**Technical Report
Administrative Change Notice**

1. Document Number: 000-30R-MGR0-02000-000	2. Revision: 001	3. ACN Number: 02
4. Title: Seismic Analysis and Design Approach Document

Figure 6-8. Horizontal Design Response Spectrum for Non-ITS Surface Facilities, Five-Percent Damping

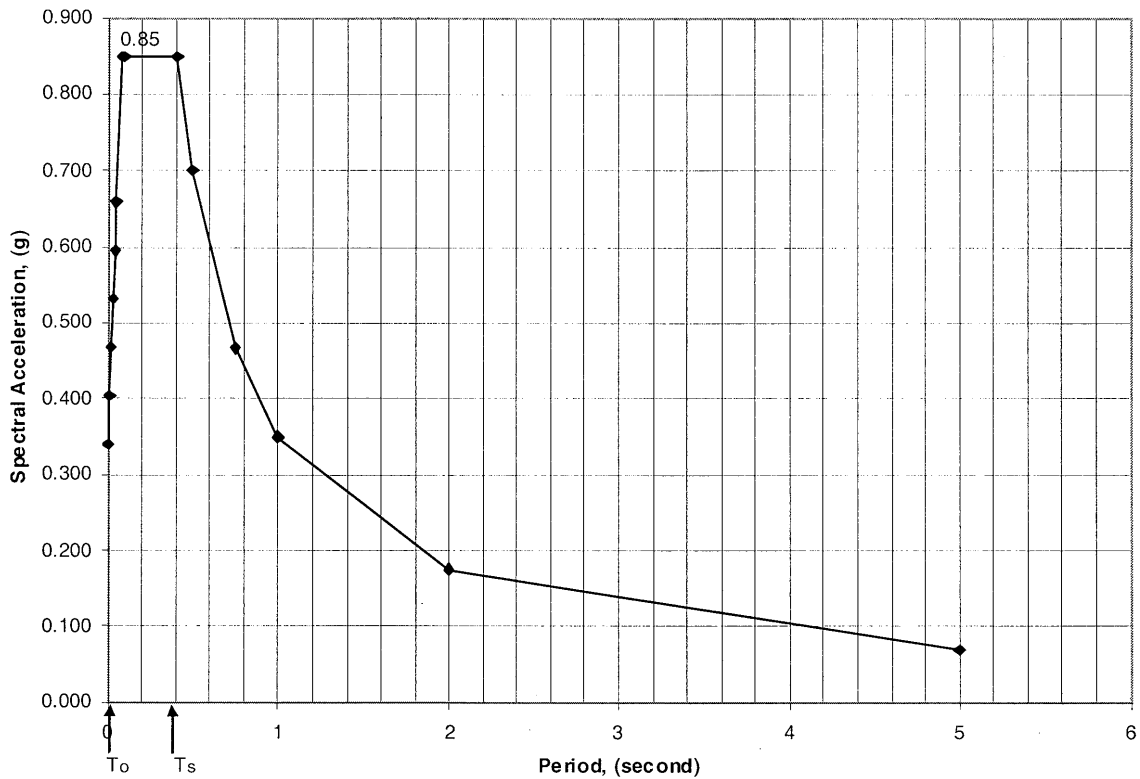
7. Affected Pages:	8. Reason for, and Description of Change:
Page 49, Section 7.7.1, 1 st paragraph, 2 nd sentence	Update reference from Figure 6-7 (now deleted) to the applicable DTN. Change “. . .(see Figure 6-7 for. . .)” to “. . .(see DTN: MO0805DSRB5E4A.000 [DIRS 185935] for. . .”.
Page 50, Section 8.2, 2 nd paragraph, 2 nd sentence	Editorial correction. Change “. . .the these codes. . .” to “. . .these codes. . .”.
Page 50, Section 8.2, 2 nd paragraph, last reference	Update reference title. Change “IBC 2000 [DIRS 173525]” to “IBC 2000 (ICC 2003 [DIRS 173525])”.
Page 51, Section 8.3.1, 2 nd paragraph, 2 nd sentence, Notation L, last line	Editorial corrections and correct reference number. Change “. . .earthquake (where justified, a higher percentage may be used) (IBC 2000 (ICC 2000 [DIRS 173525], Section 1617.5.1))” to “. . .earthquake (where necessary , a higher percentage may be considered) (IBC 2000 (ICC 2003 [DIRS 173525], Section 1617.5.1))”.
